## Application for Works Approval

**Works Approval Number** W6734/2022/1

**Applicant** MARBL Lithium Operations Pty Ltd

**Decision** Works approval granted

**Figure 6 - Atlas in-pit TSF and modelled potential surface expressions of groundwater seepage (without controls) mapped with seepage recovery bores (in blue) and monitoring bores (in yellow).**

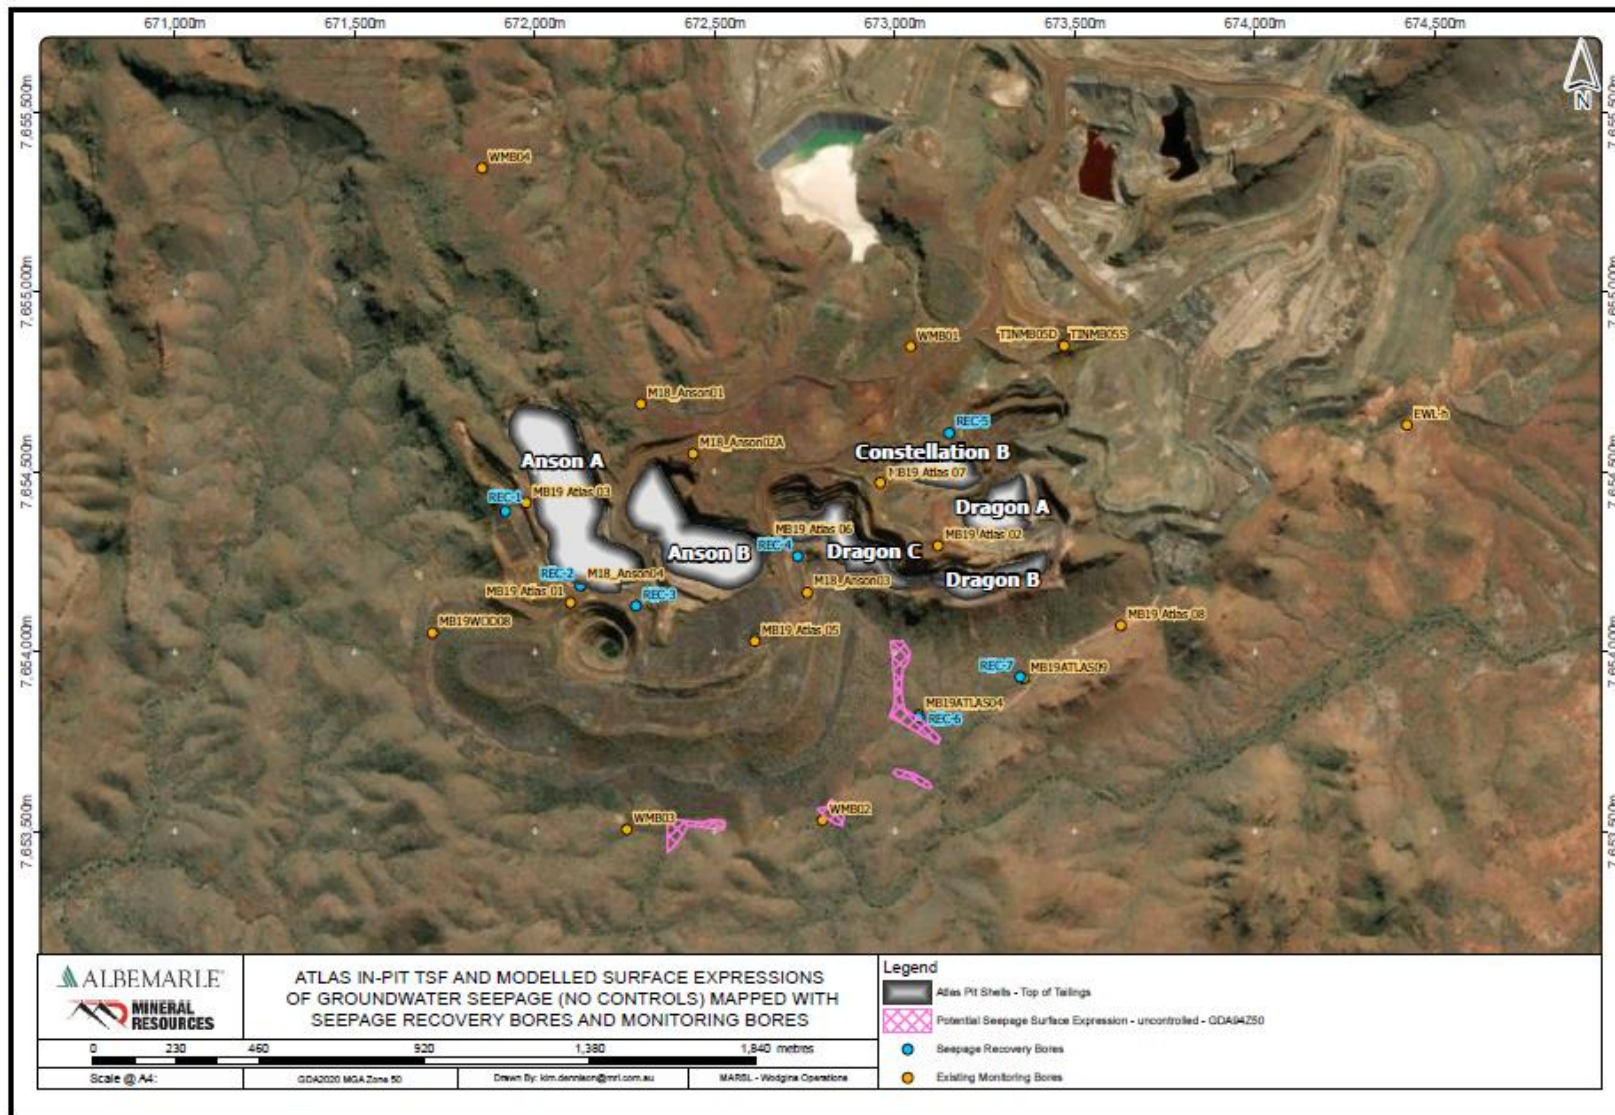
- The groundwater flow model that has been developed by AQ2 consultants is considered to be technically sound and generally has been developed in accordance with the principles and guidance that is provided in the Australian groundwater modelling guidelines. However, the AQ2 report does not adequately consider the level of uncertainty that is associated with the model predictions. CSB recommends that the current model predictions about the fate of seepage from the TSF are considered to be only the best estimates that are currently available. It is important that sufficient monitoring is undertaken during the life of the in-pit TSF to verify the model predictions. It is particularly important that areas where groundwater could emerge at the land surface are identified with ongoing groundwater monitoring, as these are locations where recovery bores would need to be installed to prevent this taking place.

CSB recommends that the current model predictions about the fate of seepage from the TSF are considered to be only the best estimates that are currently available. It is important that sufficient monitoring is undertaken during the life of the in-pit TSF to verify the model predictions.

- A. Developing a contingency plan for responses to groundwater trigger value exceedances; and**
- B. Undertaking periodic reviews of the suitability of the numerical groundwater model.**

**Figure 10: Modelled surface expression of seepage (without controls) in relation to surface hydrology lines.**

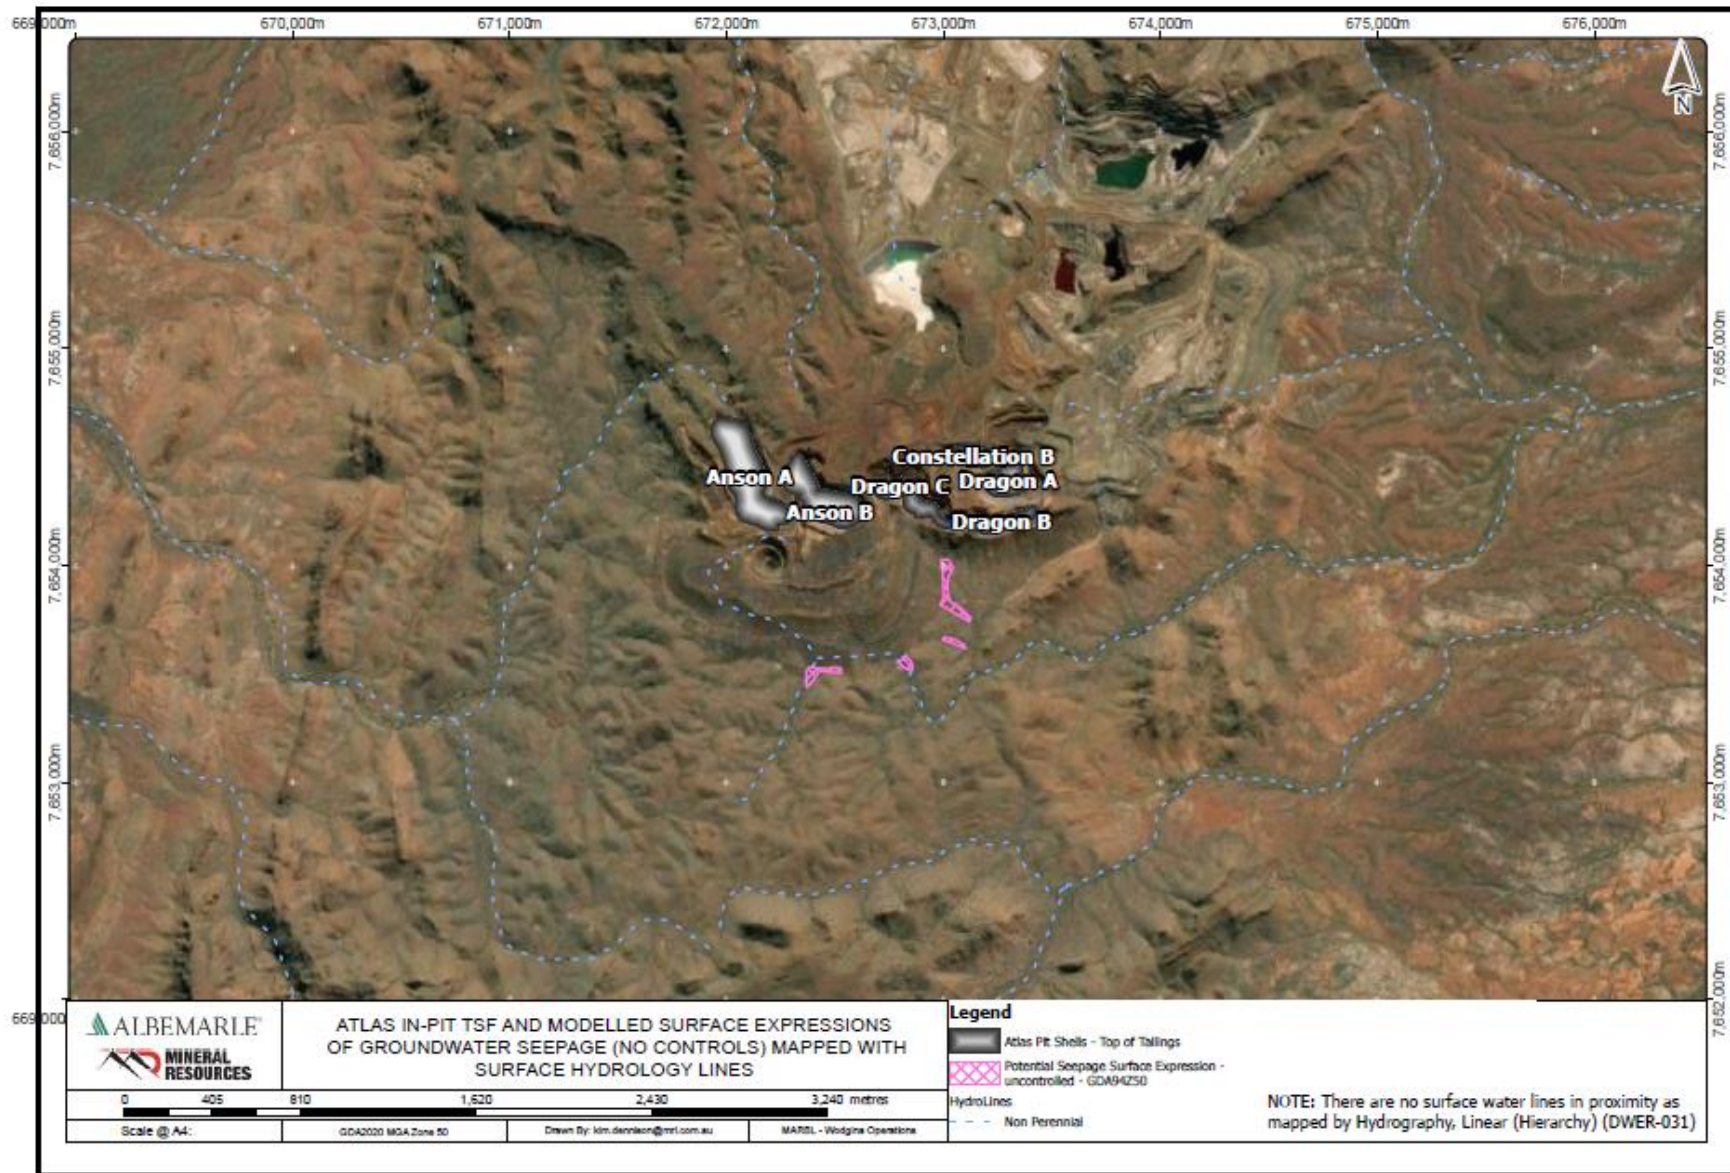
It is noted by AQ2 that ponding at the surface does not necessarily mean surface expression of seepage water outside of the TSF. Most of the predicted ponding is a hydraulic response to seepage recharging the groundwater table beneath the tailings deposition pits. That is, the water table is “pushed up” by the transmission of hydraulic heads through the aquifer system. Seepage particles migrate much more slowly through the aquifer system compared to the migration of hydraulic heads.
